## CITY of NOVI CITY COUNCIL

### Agenda Item 1 September 24, 2018

**SUBJECT:** Consideration of the request of Orville Properties, LLC for Tentative Approval of Zoning Map Amendment 18.724 for a Planned Rezoning Overlay (PRO) Concept Plan associated with a rezoning from Expo (EXPO) to TC (Town Center). If the City Council determines that it may approve the rezoning with PRO, the City Council shall specify tentative conditions and direct the City Attorney to work with the applicant in the development of a proposed PRO Agreement. Upon completion of the draft PRO Agreement, the City Council shall make a final determination to approve, approve with conditions, or deny the rezoning with PRO. The subject property is approximately 21.48 acres and is located at 43700 Expo Center Drive, north of Grand River Avenue and south of I-96 in Section 15. The applicant is proposing to develop the property as a multi-unit commercial development consisting of nine units accessed by a proposed private drive. The PRO Concept plan includes a request for an Unlisted Use Determination under Section 4.87 of the Zoning Ordinance.

**LOT LINES NOTE:**  
INTERNAL LOT LINES WITHIN THE ADRIAN CENTER DEVELOPMENT ARE SUBJECT TO MOVE.

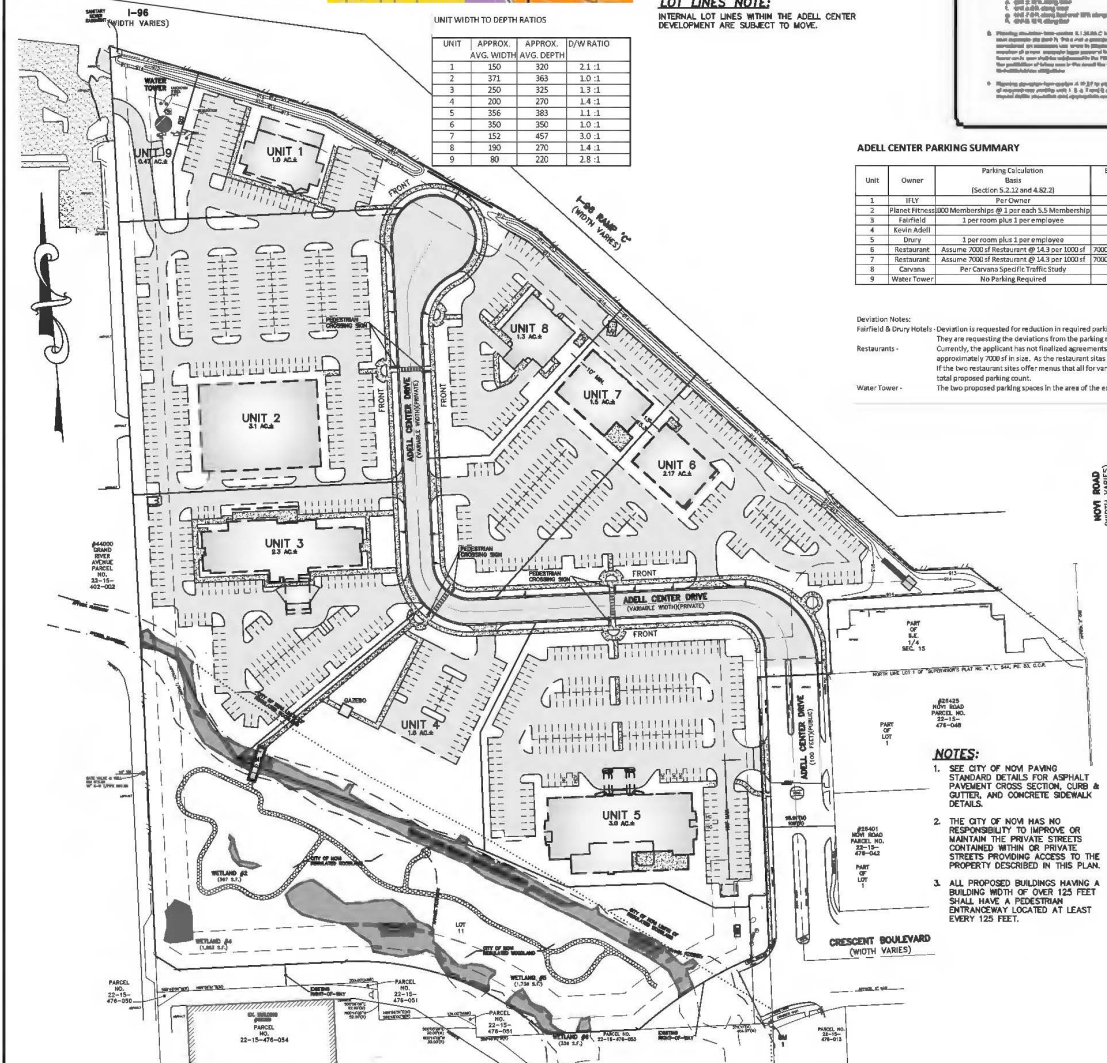
- b. A note on sheet 03 and 04 that refers to "Internal lot lines within the Adell Center Development are subject to move".
  - c. Building and Parking setbacks provided in a small inset on Sheet 2 as they conflict with the suggested deviations at August 22<sup>nd</sup> Planning Commission meeting;

- a. A note on sheet 02 that refers to "The Users are as of 08-29-18 and will be updated as new users are determined".
  - b. A note on sheet 03 and 04 that refers to "Internal lot lines within the Adell Center Development are subject to move".
